SIDEM		APPLICATION	OE-NR.
801620	Silent block	Ford Mondeo / Jaguar X-Type	1 311 417* / C2S 39662*
809631	Silent block	Opel / Vauxhall Corsa - Combo - Meriva - TwinTop	3 52 366 / 9 199 961
809633	Silent block	Opel / Saab / Fiat / Vauxhall	3 52 319 / 12 786 412 / 717 40 107 / 93 171 448
809643	Silent block	Opel / Vauxhall Insignia	3 52 868 / 13 257 785
821627	Silent block	BMW - 5 Serie E39	31 12 9 068 753
849626	Silent block	Mercedes C-Class - CLK-Class - GLK-Class	203 333 10 14
863619	Silent block	Audi A4 - A6 - A8 / Skoda Superb / VW Passat	4D0 407 183 AC

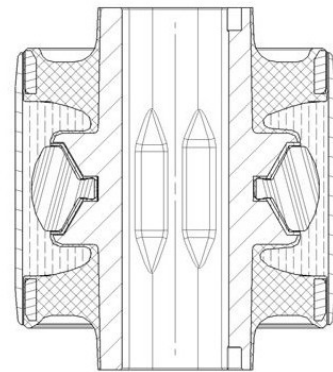
- Early wear of OE hydraulic silentblocks due to leaking making the car more difficult to handle

- The hydraulic silentblock has a thin, fragile layer of rubber on the outside. When this is punctured, the hydraulic fluid starts leaking and in no time all the resistance of the silentblock is lost

- When the OE-concept of hydraulic silentblocks shows many failures we choose to use full rubber silentblocks.

- Significant longer lifetime without reduced driving comfort.
